**CITY OF TEMPE
DEVELOPMENT REVIEW COMMISSION**

**Meeting Date: 02/24/2015
Agenda Item:**

ACTION: Request for Development Plan Review of a new sanctuary and parish house for Iglesias De Dios Pentecostal Church located at 906 South George Drive. The applicant is Rene Rivera, 3R Construction Group.

DPR14132 Development Plan Review including site plan, building elevations, and landscape plan

ARCHITECTURAL SITE PLAN

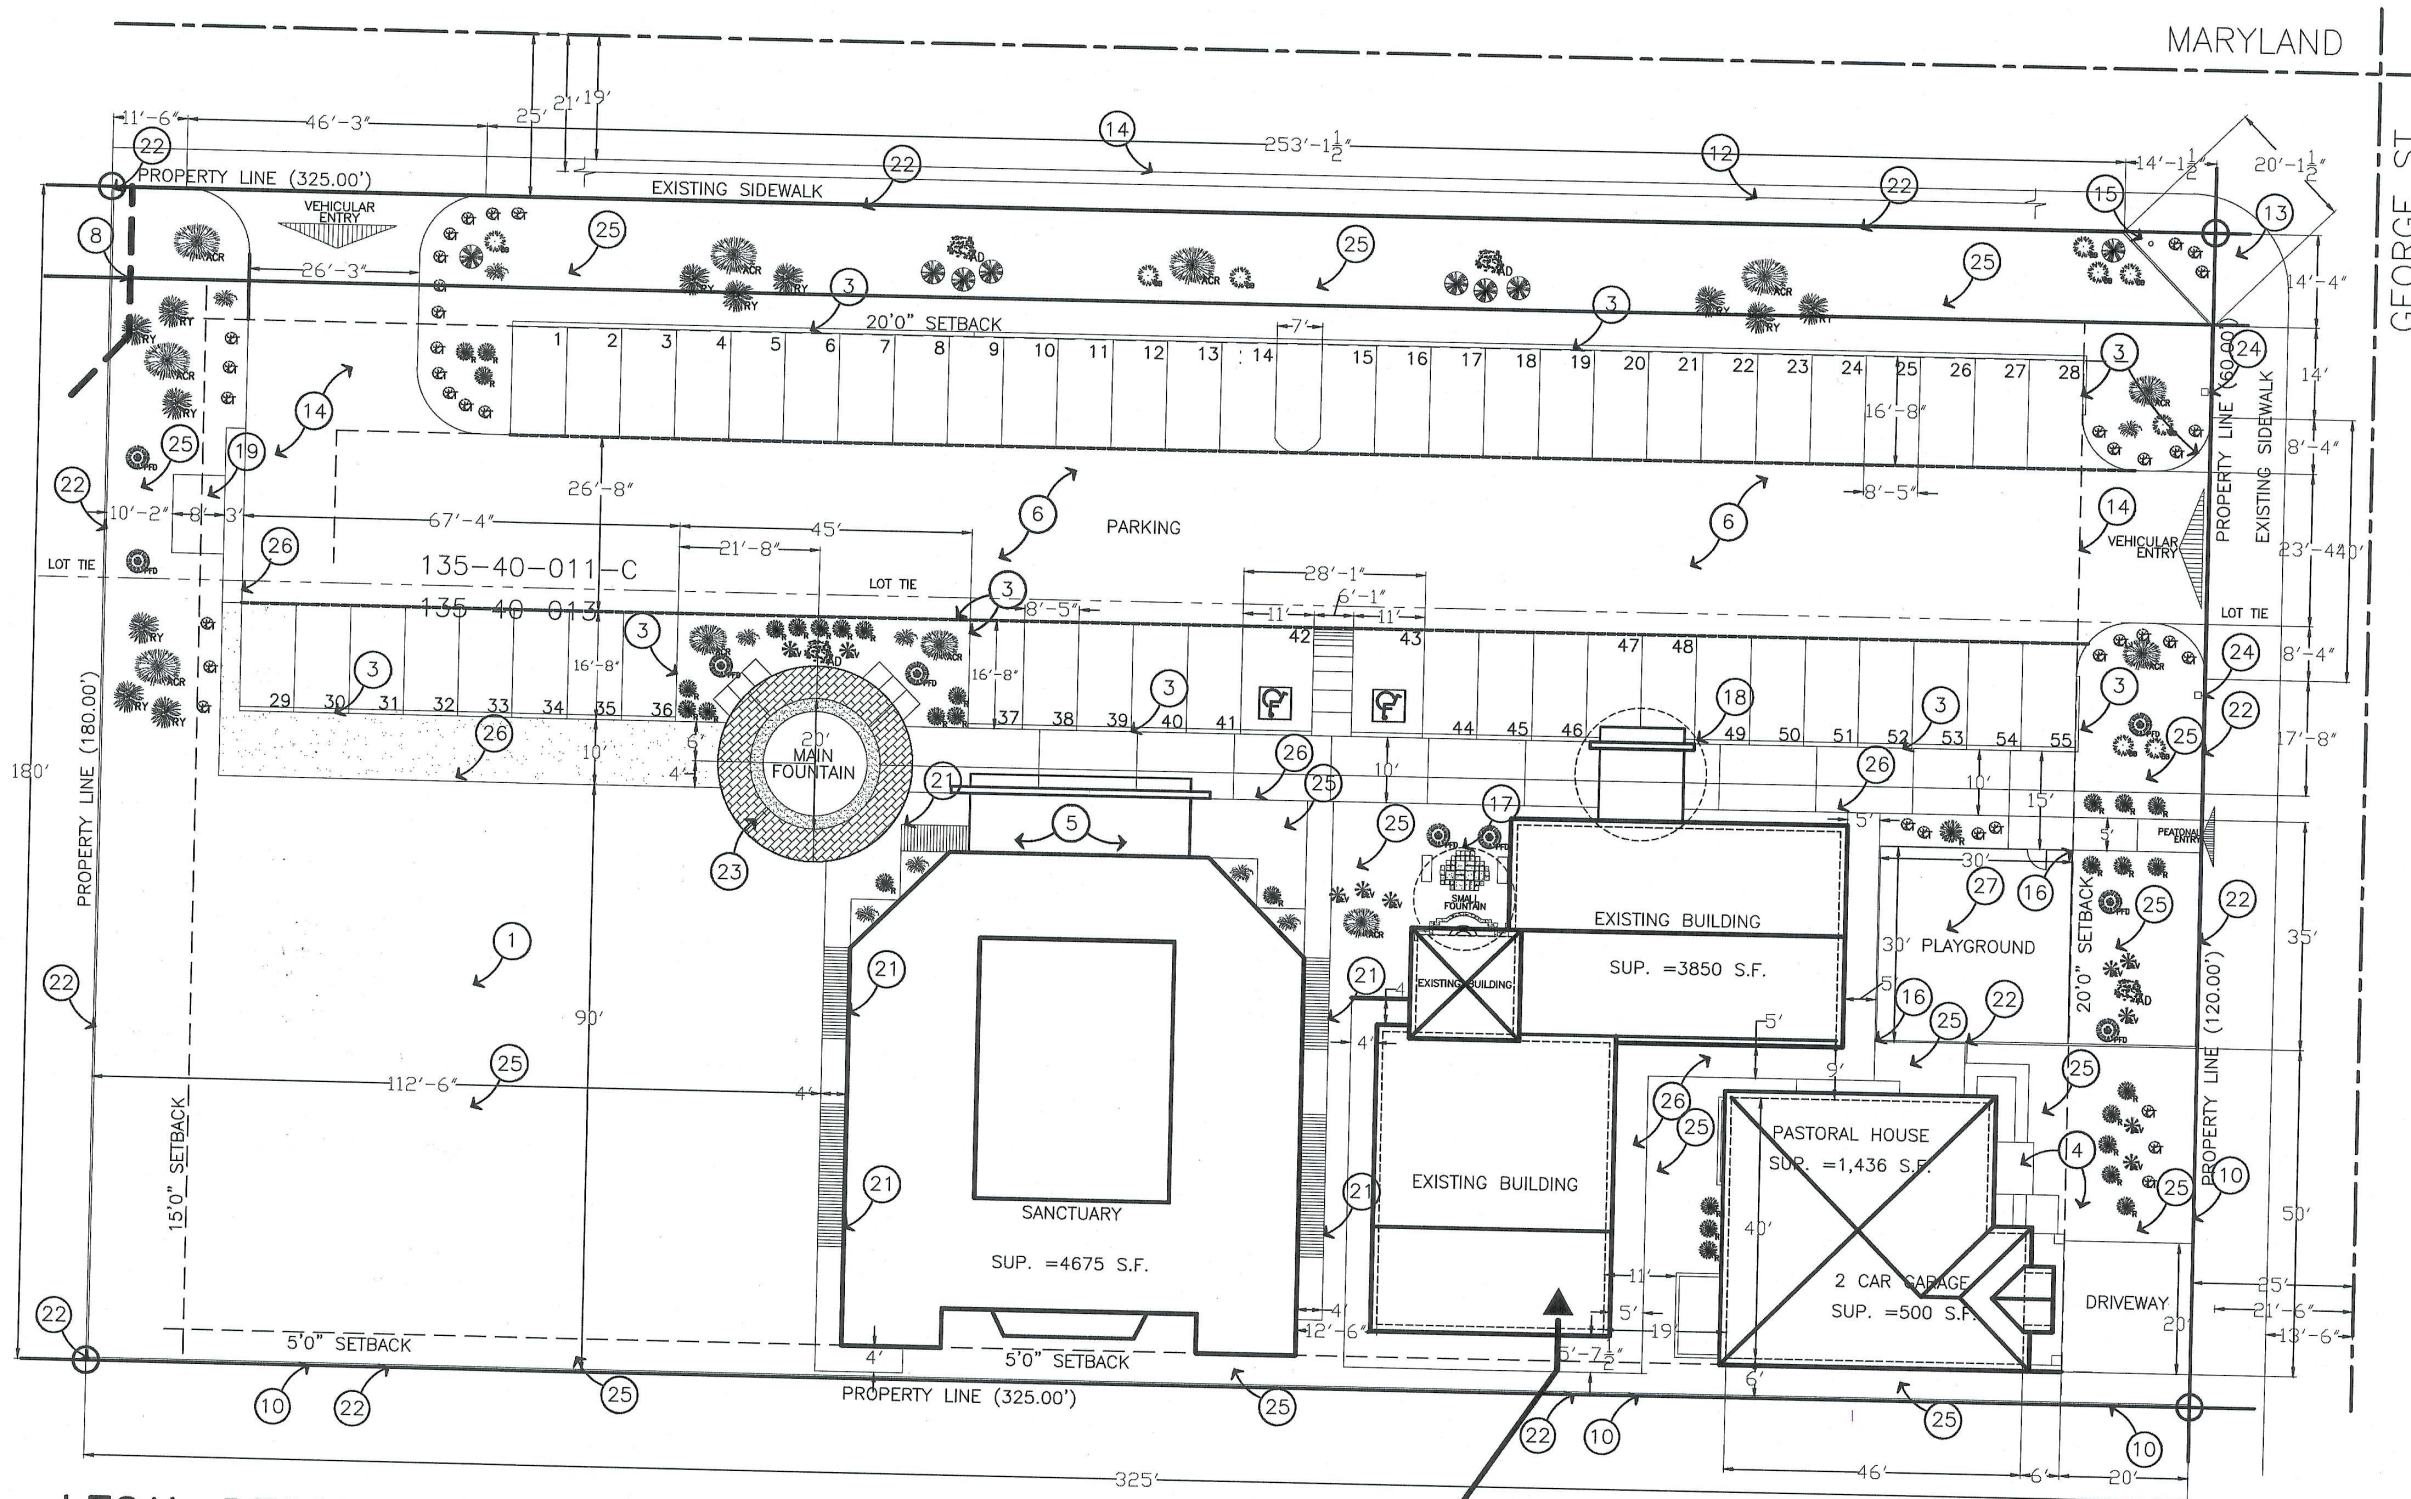
The building inventory includes two existing buildings in line on the southern portion of the site. The proposed Sanctuary building is positioned to the west of the existing building with the parish house along the George Drive street front. The future fellowship hall is planned as the most western building on the site. The parking area is located on the north side of the building accessible from both street frontages. All the buildings will flow together with exterior courtyards with water fountain features, landscape, and seating

The current site is very sparse of landscape material. Enhancement of landscape elements on site, include the addition of a variety of 2' and 3' shrubs. No canopy trees are shown along the street frontage or in the parking areas. The final landscape plan to be reviewed in as part of the plan check. Show the required trees along the street frontages (in a quantity of 1 per 30 lineal feet) and trees in the parking lot landscape areas. As a supplement to buffering trees on the west and south property lines are enacted by conditions of approval.

2. Replace any chain link used on plan with ornamental iron.
3. Construct the enclosure in accordance with standard detail DS-116 except use slump block concrete masonry units that match the buildings.
4. Locate a required, minimum 7'-0" wide Landscape Island at 15 parking space intervals. Consider locating adjacent to ADA spaces to service as one of the islands.
5. Show bike parking adjacent to the entrance to sanctuary, on a concrete pad and not in landscape areas or impeding pedestrian flow.
6. Finish utility equipment boxes for this development in a neutral color (subject to utility provider approval) that compliments the coloring of the buildings. Do not paint over warning decals or other identifiers on utility boxes.
7. Place exterior, freestanding backflow assemblies in pre-manufactured, pre-finished, lockable cages (one assembly per cage).

13. Provide one thorn less canopy tree of 24" box installation size in each required landscape island. Provide five ground covers per each required landscape island.

14. Provide upright tree buffer of minimum 24" box installation size along the west property line. Space trees at approximately 25'-0" on center.
15. Supplement landscape plan with fourteen canopy trees of minimum 24" box installation size. Trees may be clustered along the length of the two street frontages.

SANCTUARY ELEVATIONS

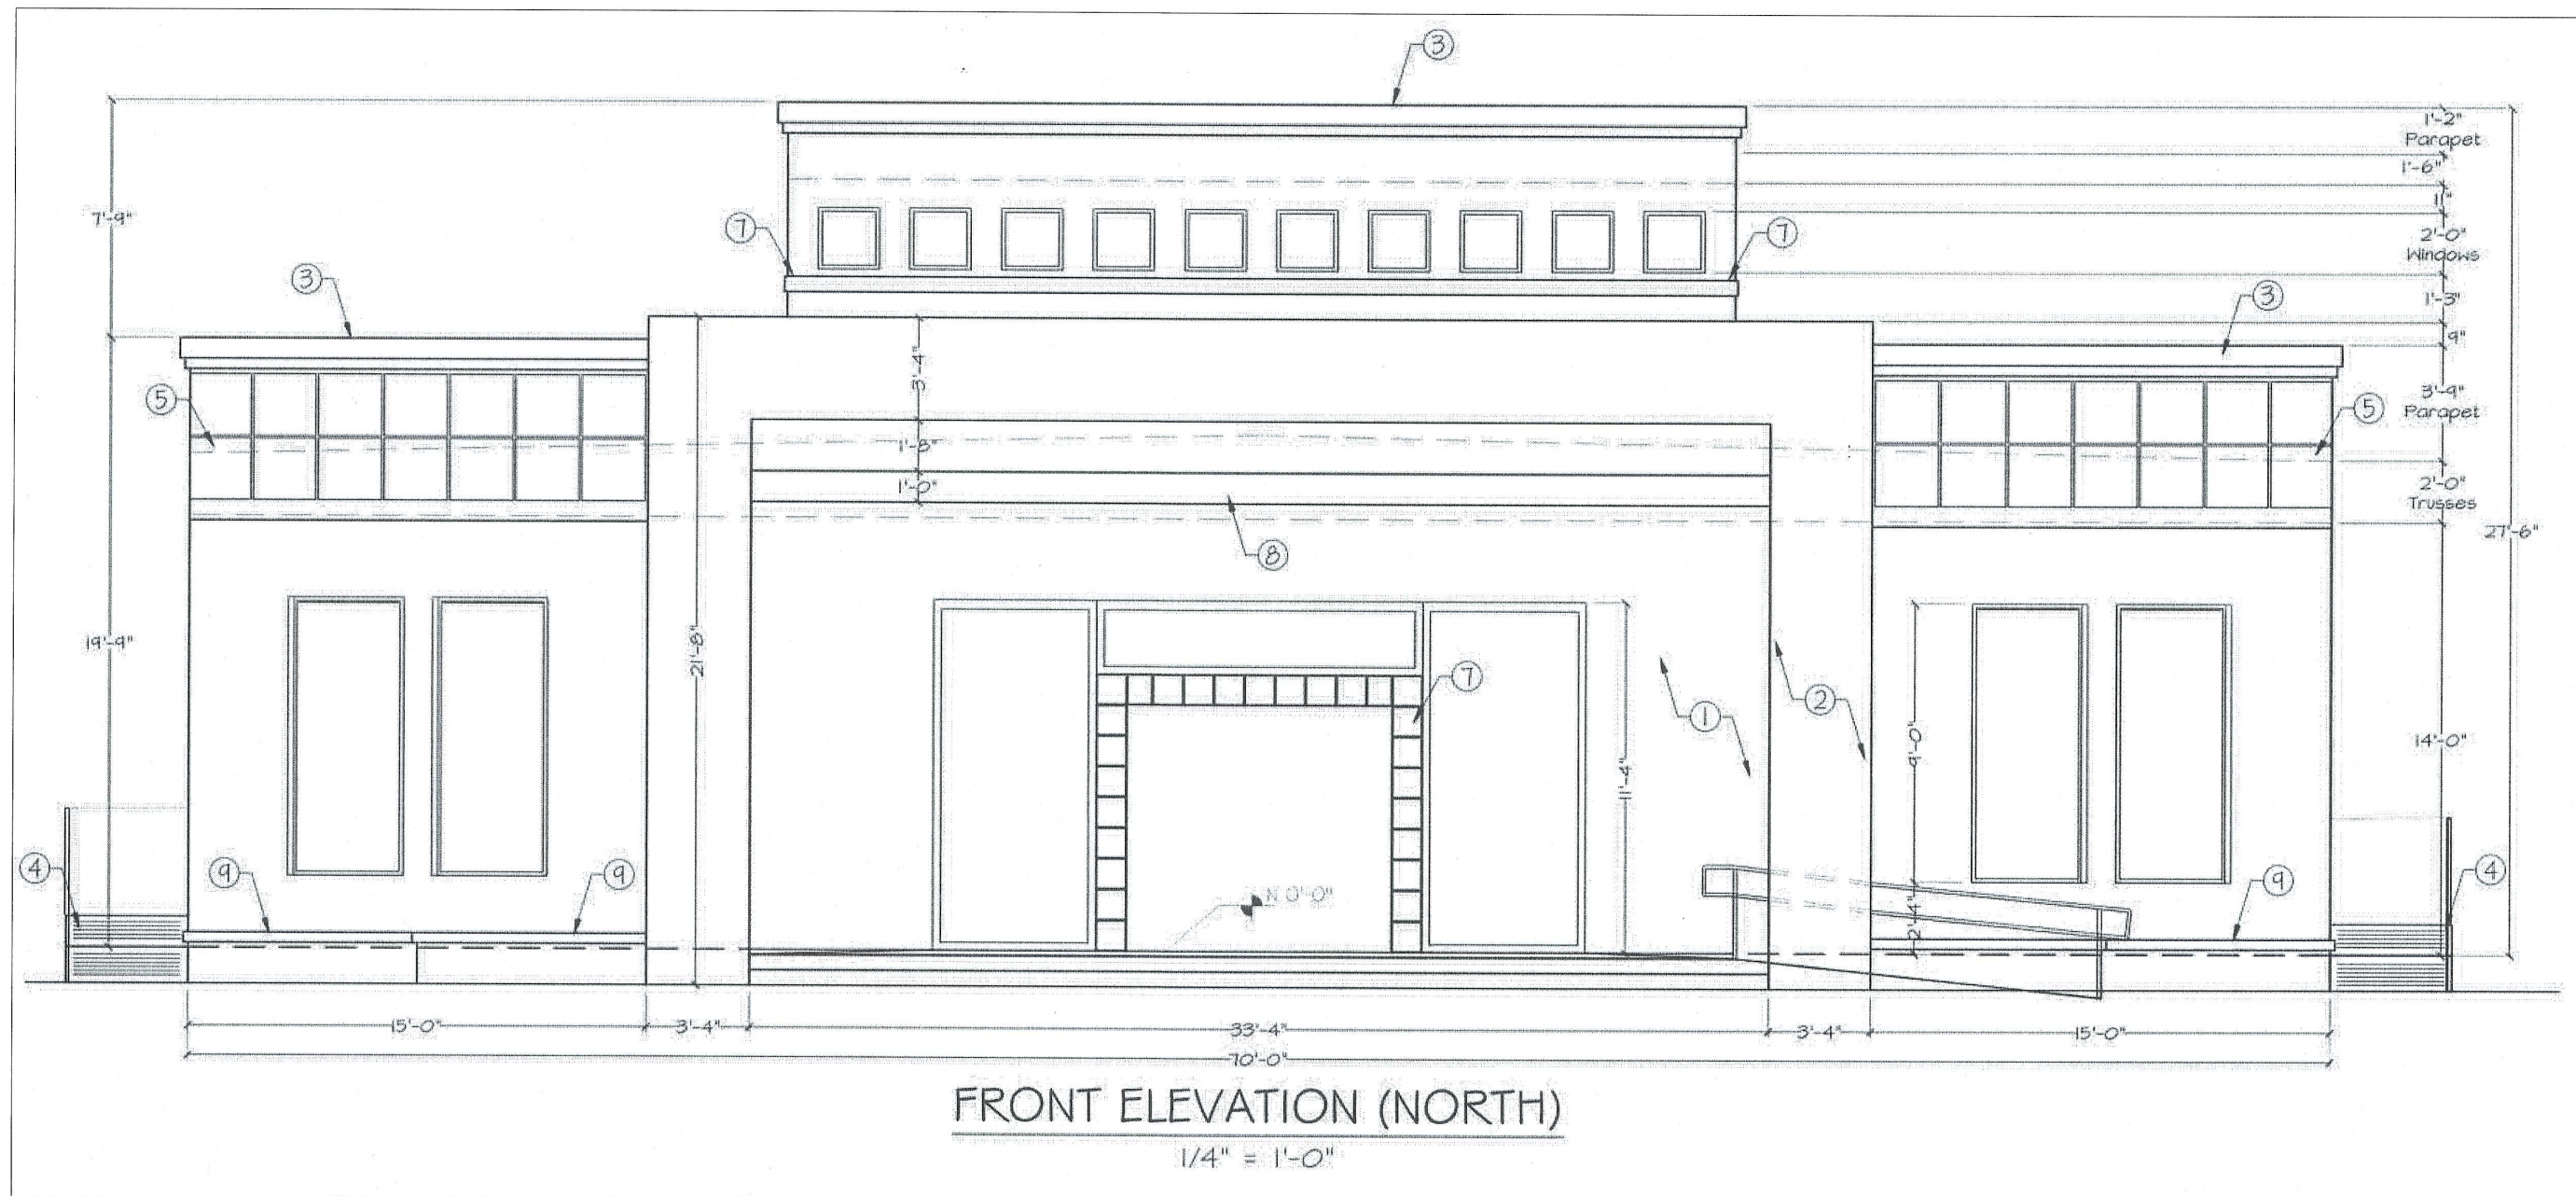
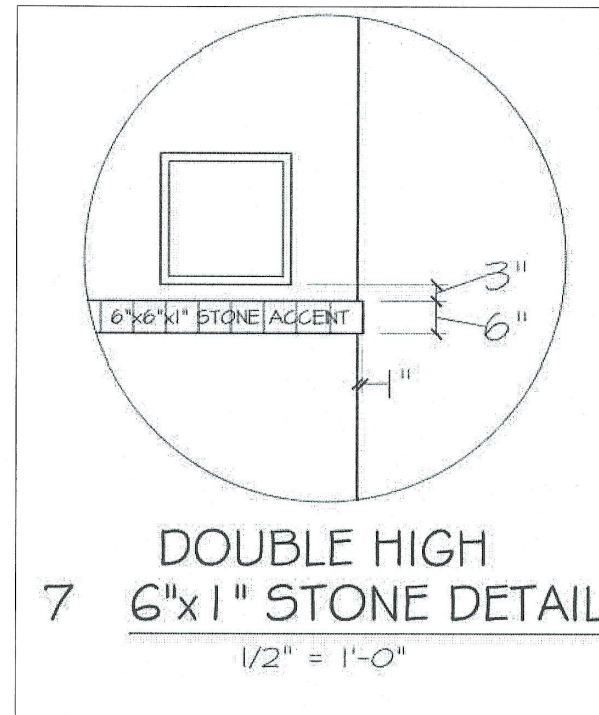
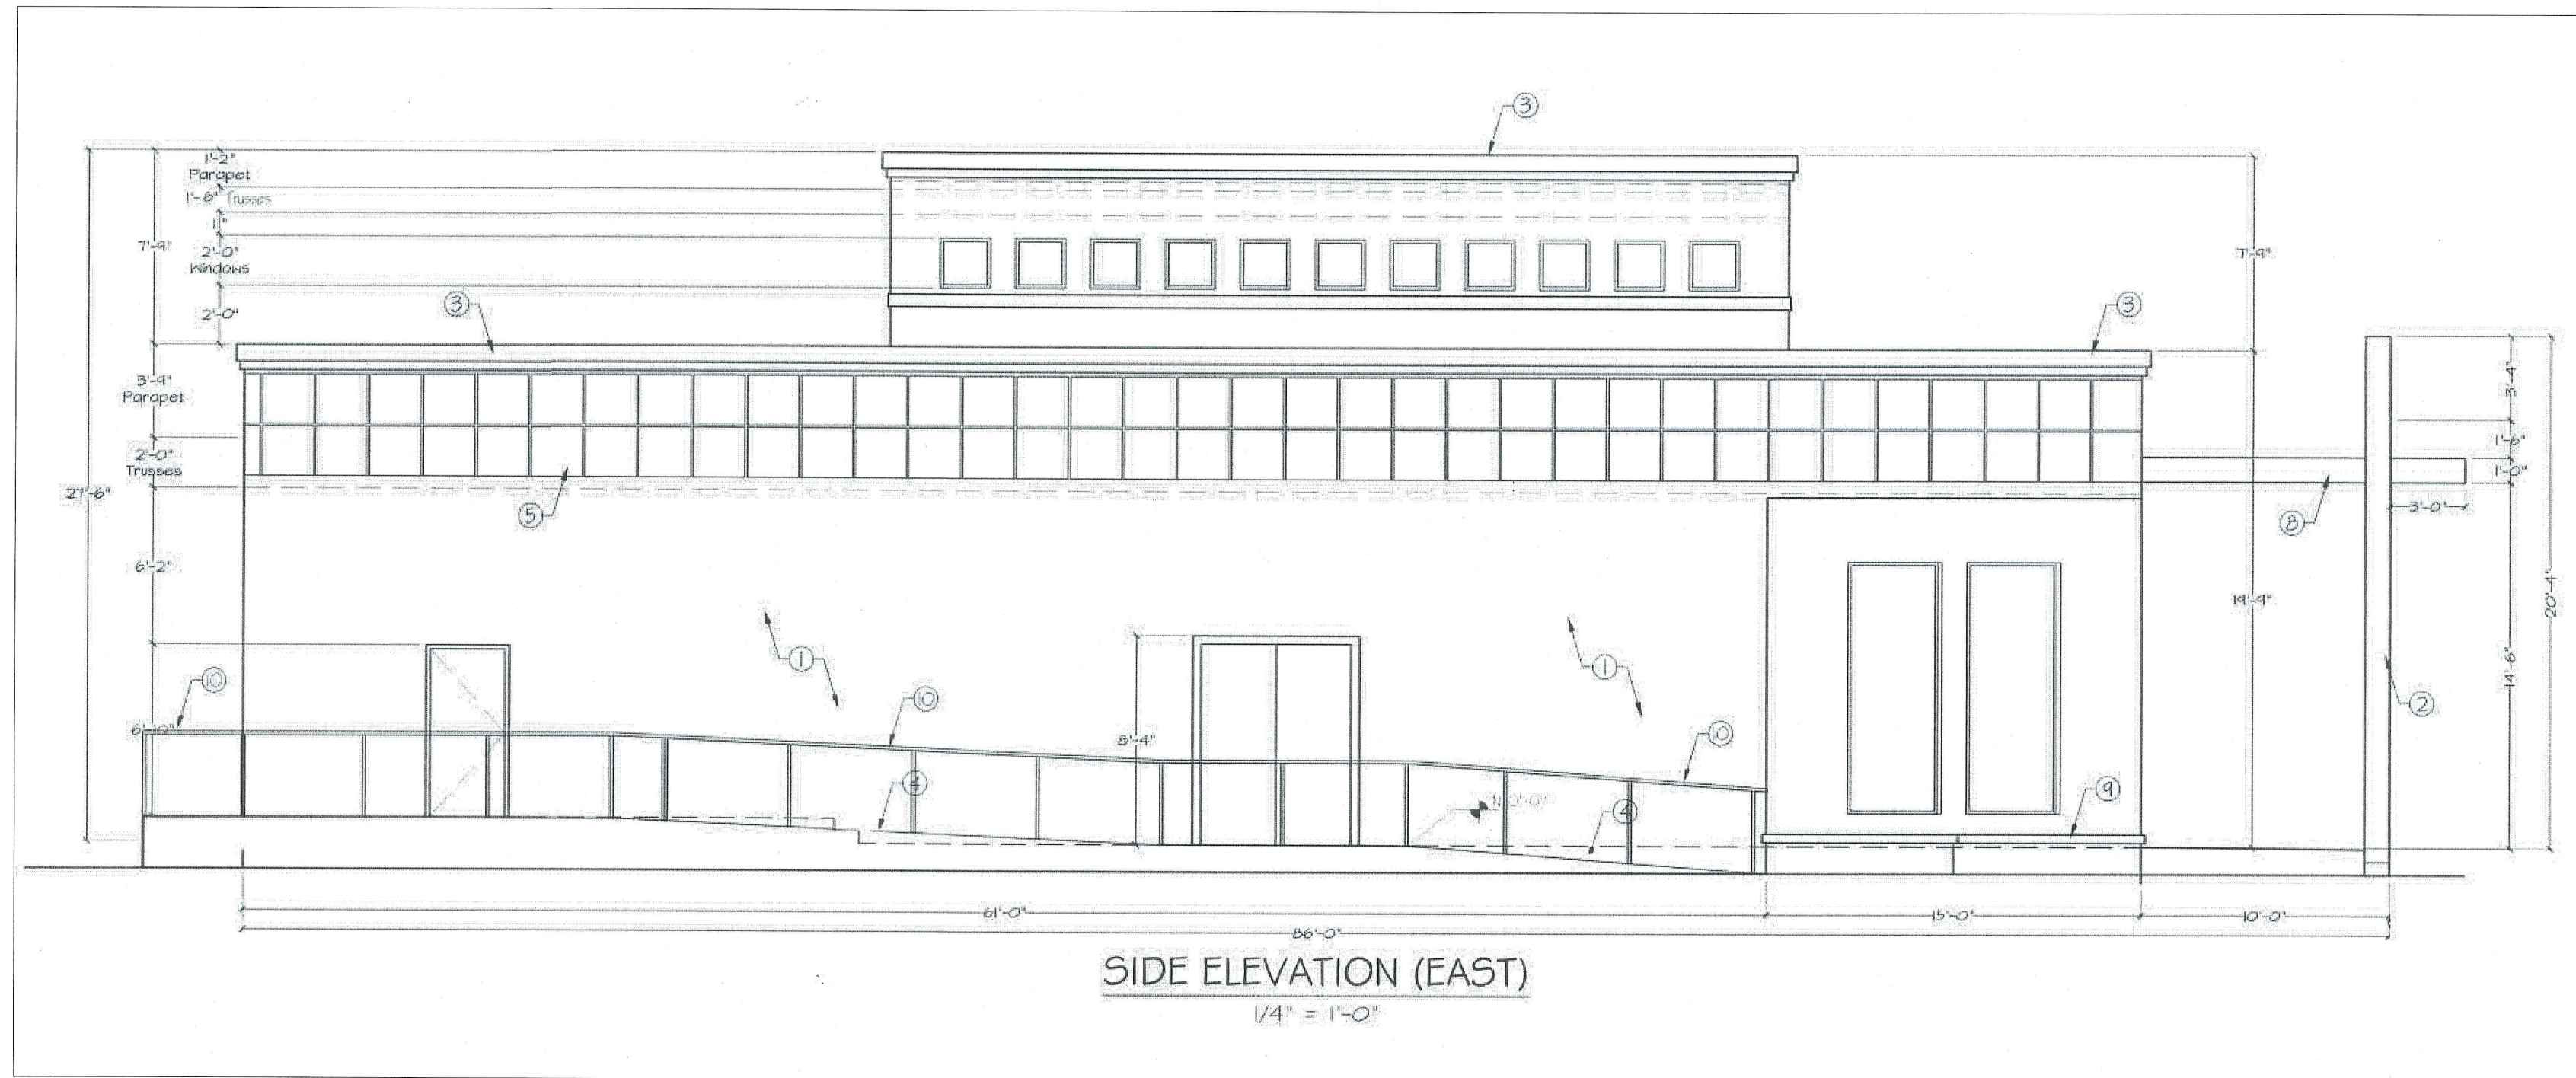
The one-story building form is has a pitched shed roof form with intersecting arch elements at the main entrance. The materials and finishes of the proposed buildings are a combination of exposed concrete and stucco and intended to blend the existing buildings. The building walls of the existing building are is a stucco finish.

- 5. Large building masses are sufficiently articulated so as to relieve monotony and create a sense of movement, resulting in a well-defined base and top, featuring an enhanced pedestrian experience at and near street level;*
The building has been designed for visual prominence at the entrance. The elevation features a defined base the

masonry and top created by the raised element with a sloped roof with clearstory windows. The simple building mass is well articulated and features a well-defined base and top. The vehicular as well as pedestrian experience in the public right of way adjacent to the site is enhanced by the building, site and landscape design.

8. Existing building to be painted to match new color scheme of Sanctuary and Parish House
9. Incorporate lighting, address signs, and incidental equipment attachments (alarm klaxons, security cameras, etc.) where exposed into the design of the building elevations. Exposed conduit, piping, or related materials is not permitted.
10. Locate the electrical service entrance section (S.E.S.) inside the building or inside a secure yard that is concealed from public view.
